**Application ref: RC190034, The Orchards Retirement Village**

**Response to SWDC s92 Request**

**Murphy's Orchard Retirement Village: Traffic Response to Section 92 Matters**

Incl. Design Response Proposed Site Plan

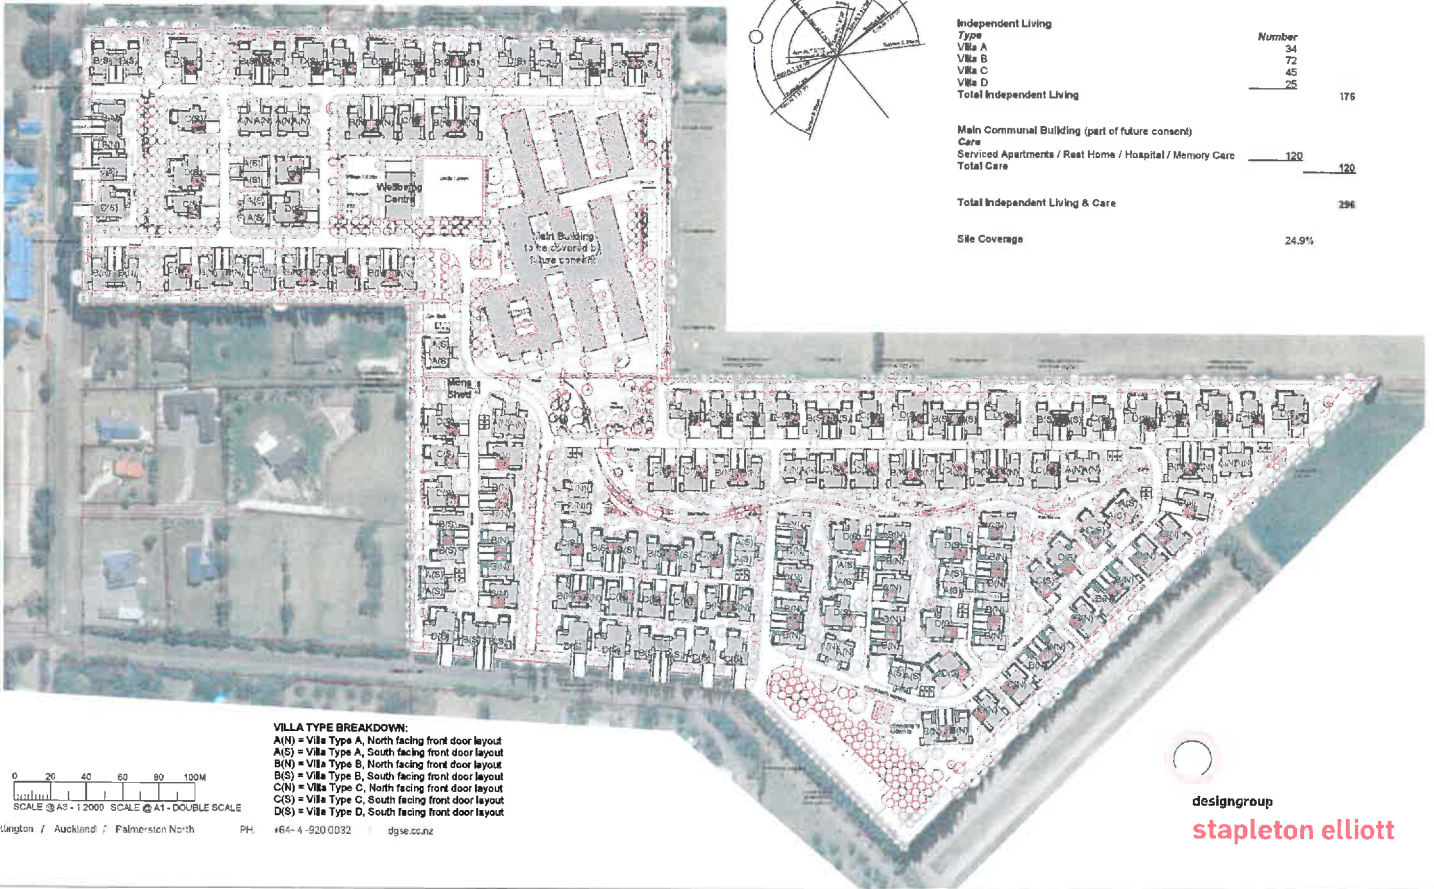
3. *"rationale as to why a width of 3m for secondary roads has been used, as they are not "side or rear access" to which a 3m width standard applies"*

4. *"a more detailed assessment as to the potential conflict between vehicles (2 way), pedestrians, cyclists, mobility scooters and visitor parking on secondary roads"*

5. *"rationale behind the proposed upgrades to Reading Street and Market Road. Note a 50km/hr operating speed would normally require a carriageway width of 8.4m, not 5.5m-5.7m as proposed"*

The 3-metre-wide lanes have been designed in accordance with NZS 4404:2010 Table 3.2 Figure E9 which has the following attributes, "Access to houses / townhouses" and generally serves one to six dwelling units. The design plans have been amended so that all the 3-metre-wide roads will be "No Exit" roads, effectively creating two additional "No Exit" lanes which only provides access to the limited number of dwelling units along each lane. These lanes will still allow pedestrian access at the ends and therefore not hamper internal connectivity.

These lanes are generally between 50 metres and 80 metres in length with intermitted driveways where passing can easily be accommodated. The updated development plan is appended to this letter. The driveways will be flush with the lane way to minimise trip hazards but also provide ample passing opportunities.

All the units with the access from these 3-metre-wide roads are also provided with a dedicated walkway in close proximity. Pedestrians, wheelchairs and mobility scooters are expected to use these walkways and are designed to the pedestrian desire lines. We suspect that cyclist will share the laneway movement lane, once again NZS 4404:2010 Figure E9 is comfortable that cyclists can share the movement lane for such low volume private access lanes. The alternating flush driveways along the length of these laneways will furthermore provide a passing opportunity approximately every 10 metres. This "shared" laneway design adds to the overall slow speed environment promoted for the proposed retirement village.

Market Road will carry far less traffic and it was agreed that E12 is the correct cross section for this section of road. This upgrade of Market Road will therefore include the addition of a footpath on one side of the road. We would suggest that such a footpath is to be constructed on the northern side of the road which in turn will link into the footpath along the proposed development frontage to Market Road as shown on the updated development plan.
